BLYTHE MESA SOLAR PROJECT

Final Environmental Impact Report/Environmental Assessment

APPENDIX O
RESPONSES TO COMMENTS

Figure 5. Ponds adjacent to the boundary (yellow line) of the northern portion of the Project site.

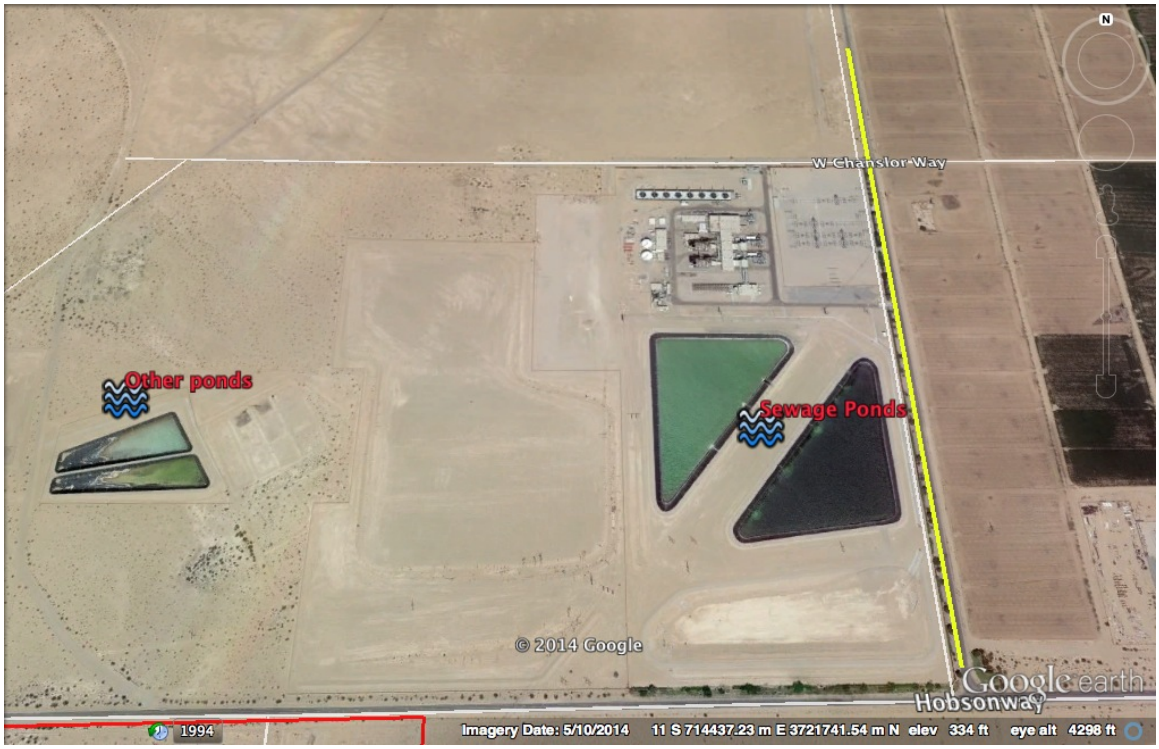
Although the Project will not have evaporation ponds, the northern portion of the Project site is located immediately adjacent to two sewage treatment ponds, and two other ponds of unknown use (Figure 5). Sewage treatment ponds are known to attract an abundance of birds due to the food they supply.[52] Based on my calculations, the sewage treatment

ponds adjacent to the Project site are approximately twice as large as the evaporation ponds adjacent to the Desert Harvest facility (Figure 6). 12a-16
